ASSESSMENT REPORT

BULGA UNDERGROUND MINE Blakefield North Modification (DA 376-8-2003 Mod 5)

Figure 5 – Noise-affected receivers

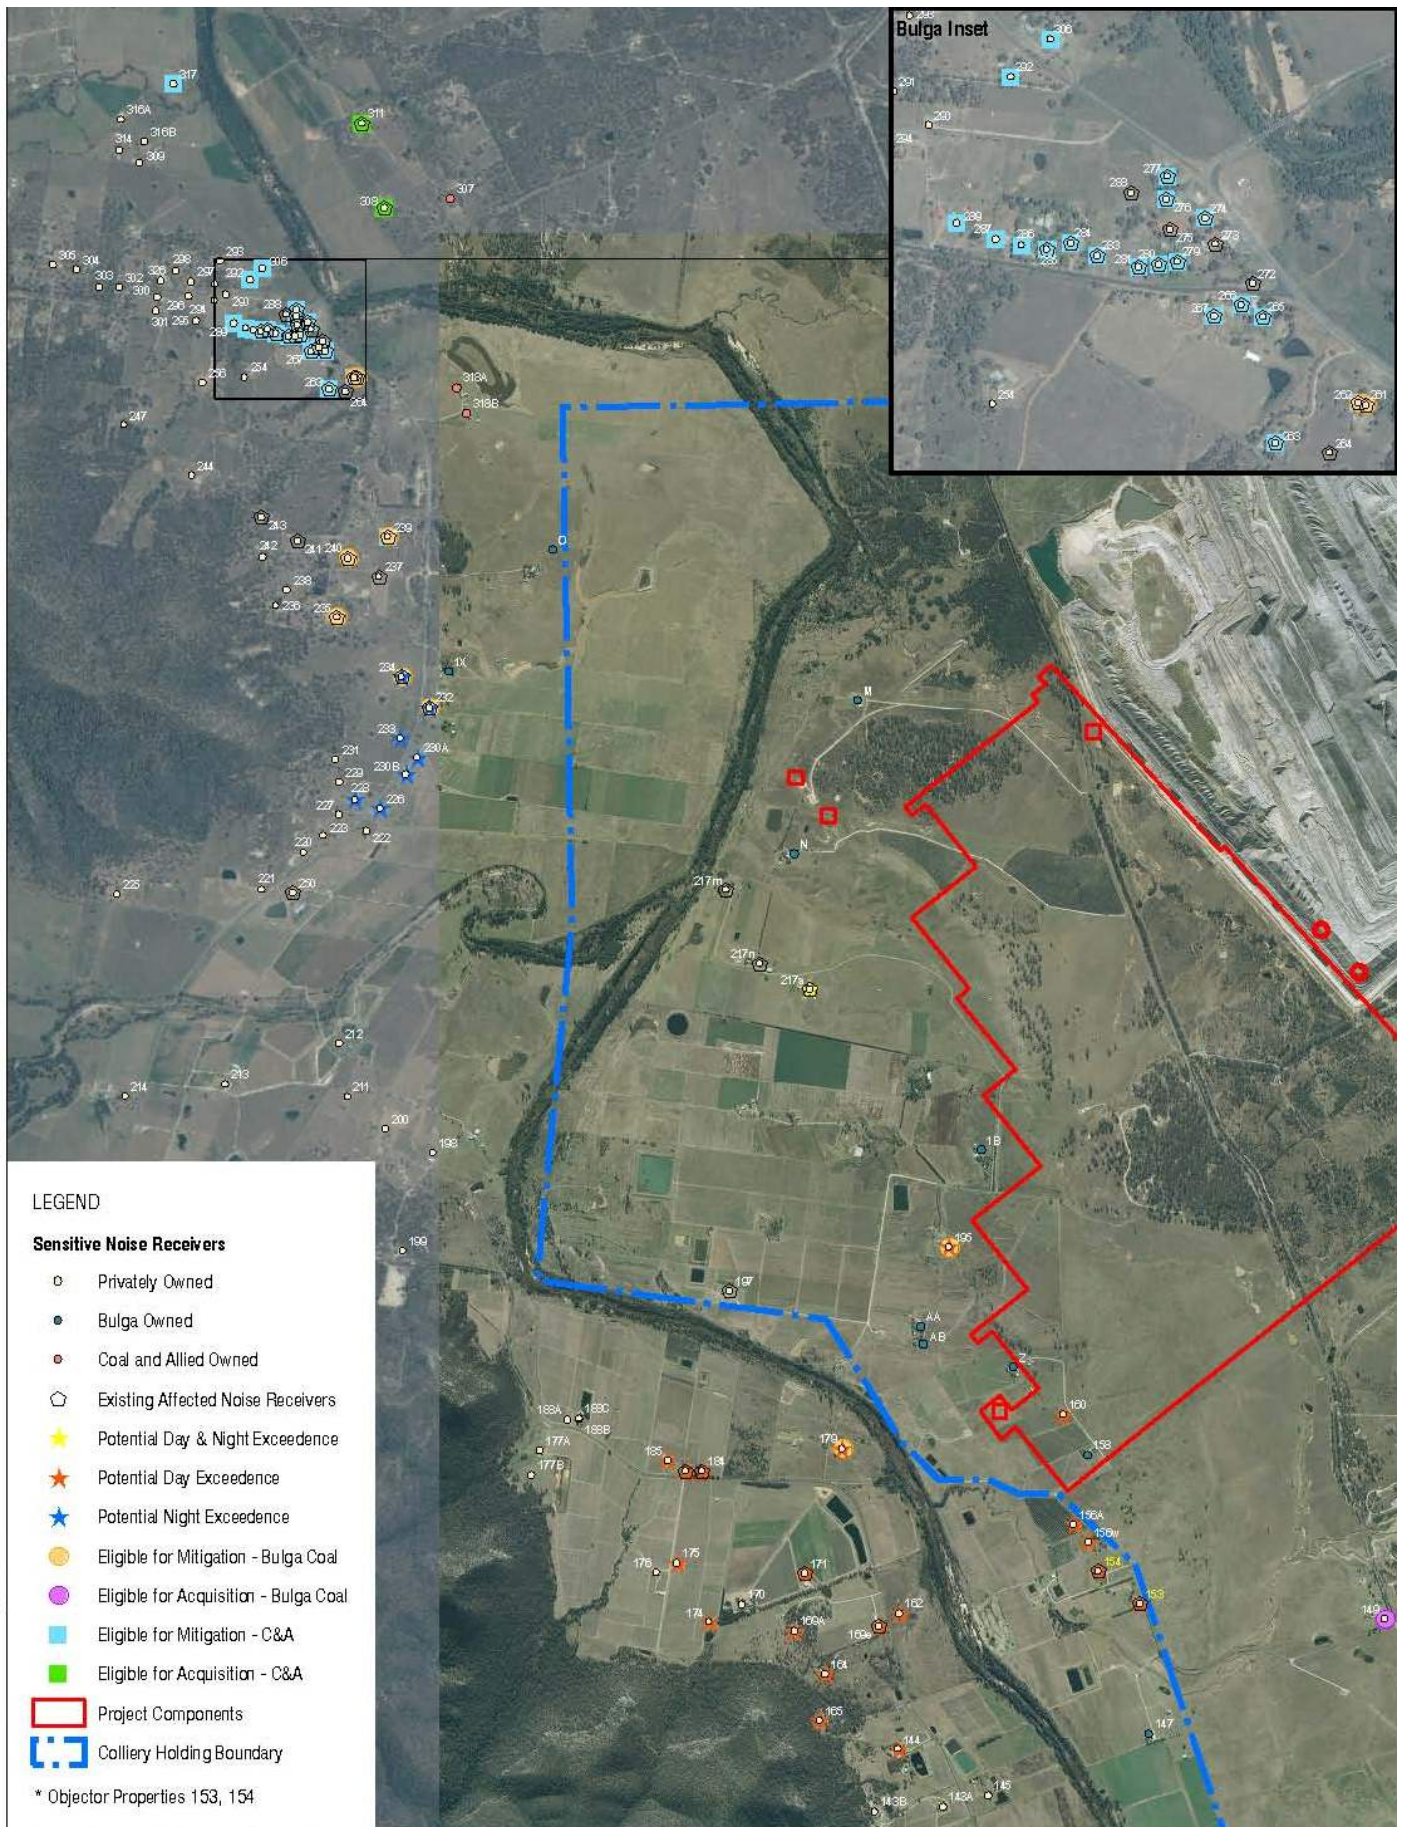
For receiver 160, which is the worst-affected of the day affected receivers owing to its location above the southwestern end of Longwall 1 and its consequent close proximity to a number of wells, predicted noise levels are above the operational noise limits on intermittent days in 5 distinct periods of approximately:

All 19 other day affected receivers are exposed to fewer gas well locations, including the objector's property (receivers 153 and 154), which is located well south of the southwestern end of Longwall 1. Receiver 154 (the nearer of the two) is some 850 m south of receiver 160.

However, one SIS well (SIS 40), located to the northwest of Longwall 7, is close enough to nearby receivers that noise levels are predicted to exceed the evening/night *operational* noise limits at 9 “night affected receivers”. The predicted exceedances:

- are not more than 1 dB $L_{Aeq\ 15\ min}$ for 8 receivers, and 2 dB $L_{Aeq\ 15\ min}$ for receiver 217;
- are dominated by emissions from the open cut mine, which means the drilling noise would be difficult to discern;
- are up to 6 dB $L_{Aeq\ 1\ min}$ above the sleep disturbance limit at receiver 217 only;
- would occur only during southeast or east-south-east winds of up to 11 km/h for 8 receivers, and only during strong inversions for receiver 217; and
- would take place over a maximum period of 4 to 6 weeks.

- specify standard ICNG construction hours at those well sites where noise levels are predicted to exceed operational noise limits, except for drilling at SIS well 40;
- require notification to affected residents well in advance of any noise levels that are expected above operational noise limits; and
- require preparation of a Construction Noise Management Plan setting out a schedule for the construction work, reasonable and feasible noise mitigation, monitoring and a response protocol should there be isolated occasions where noise impacts are higher than predicted.

Figure 6 – Overlying Linear Surface Features

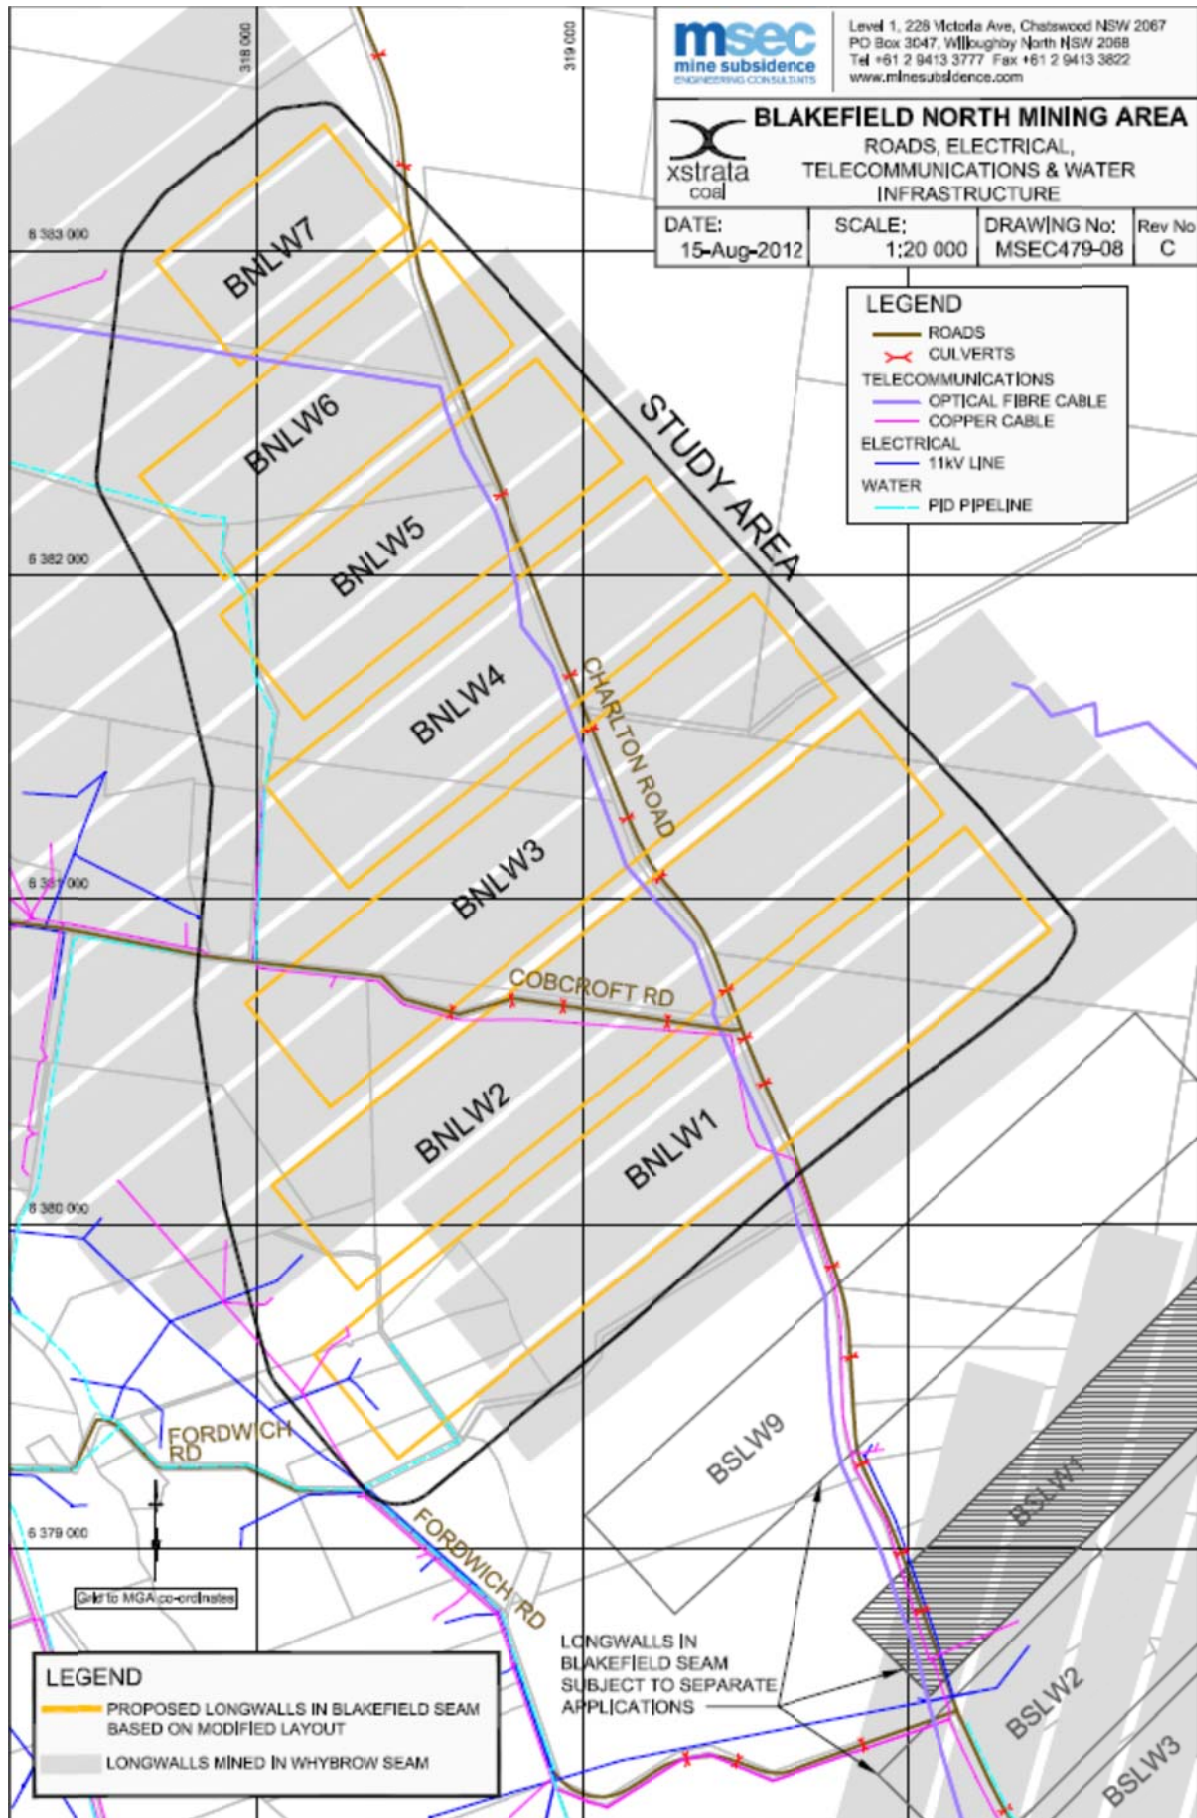
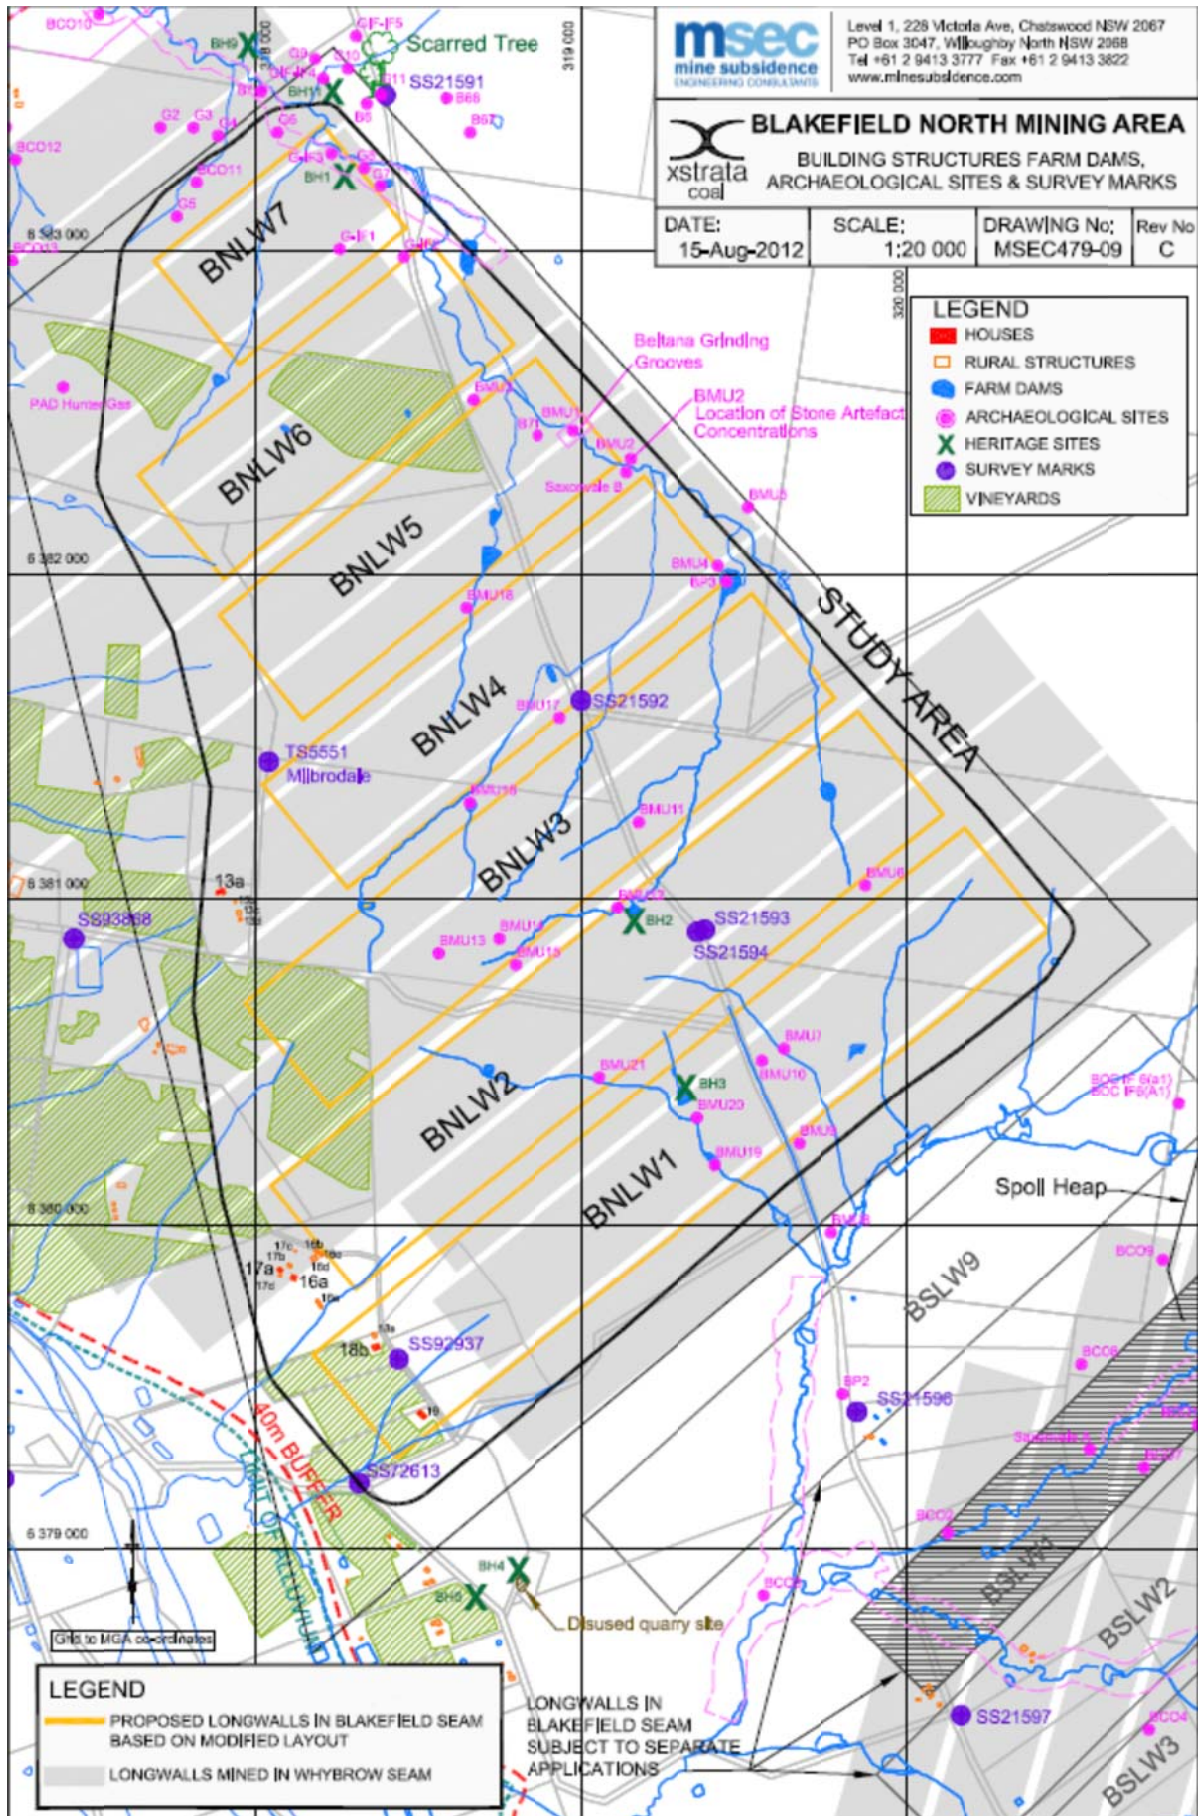
Charlton Road is a sealed Council road which follows the alignment of the Great North Road, which was a convict-era road connecting Sydney to the Hunter Valley. The alignment is historically significant in parts, although there is no NSW heritage listing for the section overlying the Blakefield North Mine. Cobcroft Road is also a sealed Council road, while Fordwich Road is an unsealed Council road. These roads and the associated road drains would undergo the full range of predicted subsidence; resulting in troughs, ponding, compression heaving and cracking, which could affect public safety and serviceability.

However, the road formations are of flexible construction and these impacts would develop gradually, in time to be observed and repaired using normal road repair methods. Charlton Road, in particular, has been previously subsided without mishap both during the single seam Beltana No 1 operation and the multi-seam Blakefield South operation. Bulga would visually monitor and inspect impacts as they occur and manage safety, serviceability and repairs in consultation with Council, according to its existing management strategy.

Telstra's fibre optic cable runs adjacent to Charlton Road and there are copper cables adjacent to both Charlton and Cobcroft Roads. These cables would experience the same range of subsidence effects as the roads and have also been previously subsided without incident under single and multi-seam mining at Beltana No 1 and Blakefield South. A duplicate of the fibre optic cable has already been installed inside a flexible duct adjacent to Charlton Road. This was a subsidence impact preventative measure before Beltana No 1 was extracted. It should withstand the additional subsidence if there is enough cable to draw at either end of the duct. Bulga would continue to manage subsidence impacts in consultation with Telstra and according to its existing management strategies.

A PID pipeline made of butt-welded polyethylene crosses the south-western end of proposed Longwalls 4, 5 and 6, and a smaller distribution line crosses proposed Longwall 3. The pipeline design was approved by the Mine Subsidence Board to withstand strains of at least 70 mm/m. This is more than the strains expected under the proposed modification. However, the MSEC report recommends the pipe should be uncovered and provided with a sand base directly above the ends of Longwalls 5 and 6 so that it is isolated from localised unconventional subsidence. Bulga has committed to do this. The pipeline has previously been subsided over the Beltana No 1 Mine and Bulga would continue to manage subsidence impacts according to its existing management strategies.

Figure 8 – Endangered Ecological Communities and Endangered Population habitat

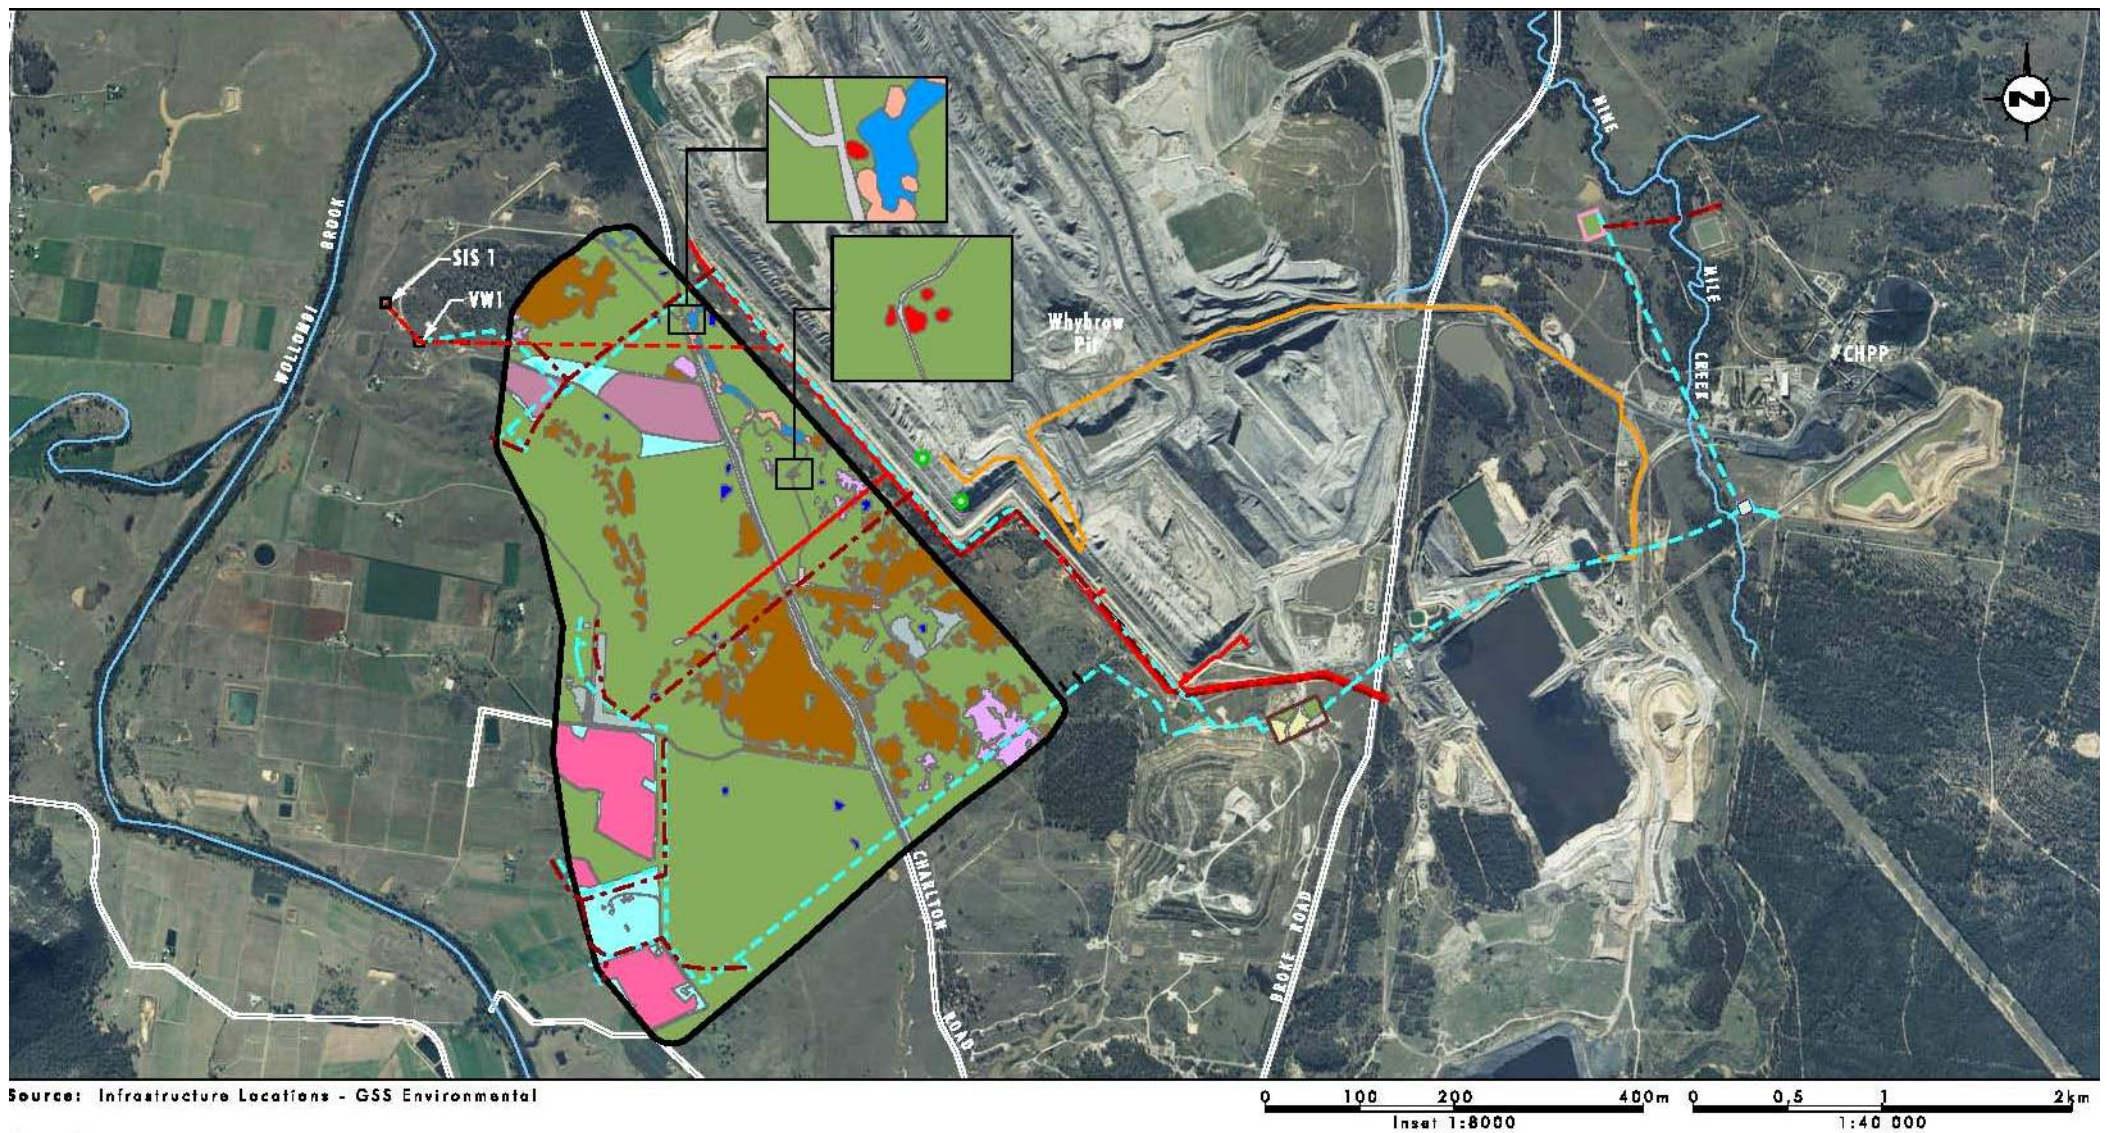
There are 2 Endangered Ecological Communities (EECs) and 1 Endangered Population within the subsidence area or the surface facilities areas, as follows (see **Figure 8**):

- 103 ha of *Central Hunter Grey Box – Iron Bark Woodland* EEC, of which approximately 5 ha would need to be cleared for the surface facilities;
- 0.15 ha of *Hunter Valley Weeping Myall Woodland* EEC; and
- 760 mature and 2050 juvenile individuals of Weeping Myall (*Acacia pendula*) which constitute an Endangered Population.

The proposal requires 5.34 ha of *Central Hunter Grey Box – Ironbark Woodland* EEC to be cleared and 23.71 ha of the associated derived native grassland. The proposal does not require any individual *Acacia pendula* to be cleared, either within the EEC or the broader Endangered Population.

The key issue regarding flora and fauna impacts is therefore the proposed clearing of 5.34 ha of *Central Hunter Grey Box – Ironbark Woodland* EEC and 23.71 ha disturbance of associated derived native grassland. The Department considers that these areas are large enough to warrant a biodiversity offset, notwithstanding that it is less than 0.05% of the distribution of this EEC. Nonetheless, individual small offsets for clearing of this scale can be inconvenient and inefficient to establish and manage. Consequently, Bulga is proposing an offset as part of a larger biodiversity offset at Reedy Valley, a large property 70 km northwest of the Complex, where it is proposing to offset the much more significant biodiversity impacts of the Bulga Optimisation Project. This would allow Bulga to consolidate (but separately count) an offset for the Bulga Optimisation Project with a number of other smaller biodiversity offset obligations, including both an existing requirement and the impacts of this current modification, on a contiguous tract of land.

The Department and the OEH both consider that Bulga's provision of an offset as part of the larger Reedy Valley offset is an acceptable and appropriate approach, given the small additional area of offset land involved in respect of this current modification. The Department has therefore included a condition in its recommended approval which requires Bulga to provide an offset for the 5.34 ha of EEC clearing and 23.71 ha of disturbance, to the satisfaction of the Director-General, by the end of December 2014.
